SUNDRY NOTICES AND REPORTS ON WELLS (DO NOT USE THIS FORM FOR PROPOSALS TO DRILL OR TO DEEPEN OR PLUG BACK TO A DIFFERENT RESERVOIR. USE "APPLICATION FOR PERMIT" (FORM C-101) FOR SUCH PROPOSALS.)		WELL API NO. 30-025-03798

2. Name of Operator Chevron USA INC		6. State Oil & Gas Lease No. B- 7766
3. Address of Operator 6301 DEAUVILLE BLVD., MIDLAND, TX 79706		7. Lease Name or Unit Agreement Name Lovington Paddock Unit

4. Well Location Unit Letter <u>D</u> : <u>660</u> feet from the <u>NORTH</u> line and <u>660</u> feet from the <u>West</u> line Section <u>36</u> Township <u>16S</u> Range <u>36E</u> NMPM County <u>Lea</u>		8. Well Number: 16

Chevron USA INC respectfully request to abandon this well as follows:

Proposed Wellbore

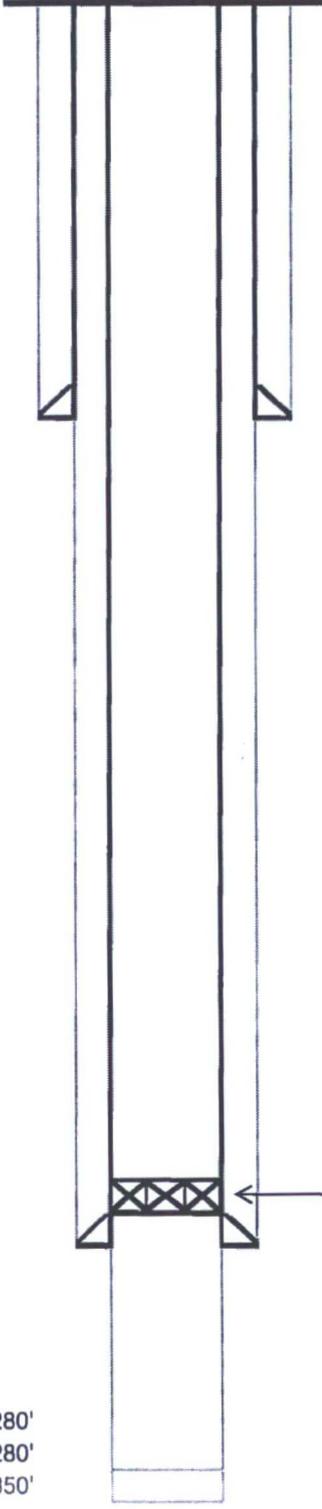
- MIRU, NDWH, NU BOPE.
- POOH with all tubing and packer if present.
- Set CIBP between 6074'-5975', circulate well with 9.5 ppm salt gel and spot 25 sx ~~525~~ of CL "C" cement on top of BP (open hole, Glorieta).
- Spot 25 sx cement plug at ~~4680'-4480'~~ (San Andres) @ 4730'
- Perf at 3160' and sqz an 80 sx cement plug at 3160'-2780' (8 5/8" shoe, base of Salt), WOC & tag.
- Perf at 2127' and sqz an 80 sx cement plug at 2127'-1881' (top of Salt, Anhy), WOC & tag.
- Perf at 500' and circulate 150 sx cement from 500' to surface on both casing strings.
- Cut all casings & anchors & remove 3' below grade. Weld on dry hole marker. Clean location.

Verify CMT to surface all strings

NOTIFY OCD 24 HOURS PRIOR TO BEGINNING PLUGGING OPERATIONS
